**DEL PUERTO CANYON RESERVOIR PROJECT  
TECHNICAL REVIEW BOARD MEETING NO. 2**

November 12, 2022

Subject: Technical Review Board Meeting No. 2, Del Puerto Canyon Reservoir Project,  
October 26-28, 2022

Figure 1: Main Dam left abutment (looking north) resistant fanglomerate ridge and wedge shaped erosional feature (TERRA/GeoPentech presentation 2022)

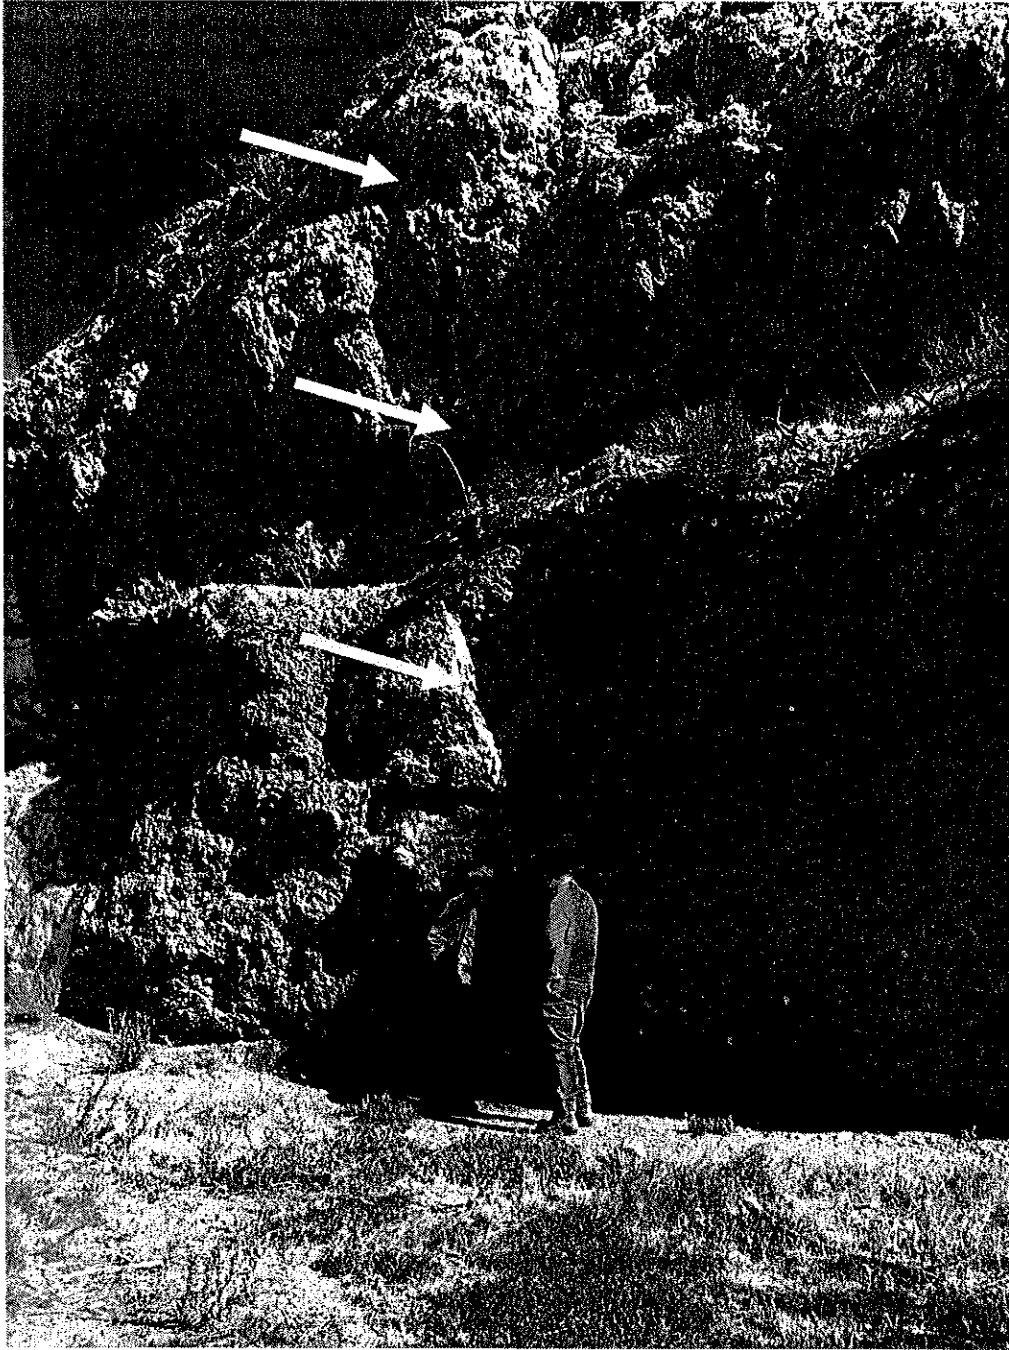
Preliminary assessment of the Main Dam foundation conditions include the potential presence for any stratigraphic bedding layers that are sheared or distorted and jointed. An exploratory borehole above the left abutment had trouble with high water losses, low core recovery, and difficult drilling conditions. While this is understandable given the conglomeritic nature of this hard, stiff stratigraphic unit, these difficulties prevent the thorough characterization needed. Also, a presumed wedge-shaped block erosion feature present nearby in left abutment (Figure 1) suggests both features should be better characterized to understand their potential effects on dam performance.

- Permeable zones that appear to be located above and below the resistant bed or ridge responsible for high takes and drill fluid loss in AB-3 (consider use of sonic borings to get better recovery and pairing of sonic drilling with mud rotary when recovery is an issue). Also, it would be important to know if these features are continuous across the entire dam foundation and not just the left abutment.

- Extent and character of the possible discontinuity near normal to bedding that formed the erosional wedge downstream of the left abutment, and the possible occurrence of the east-west joint set within the resistive ridge of this abutment (possibly by backhoe excavation along the base of the erosional feature along the western face to expose the fanglomerate).
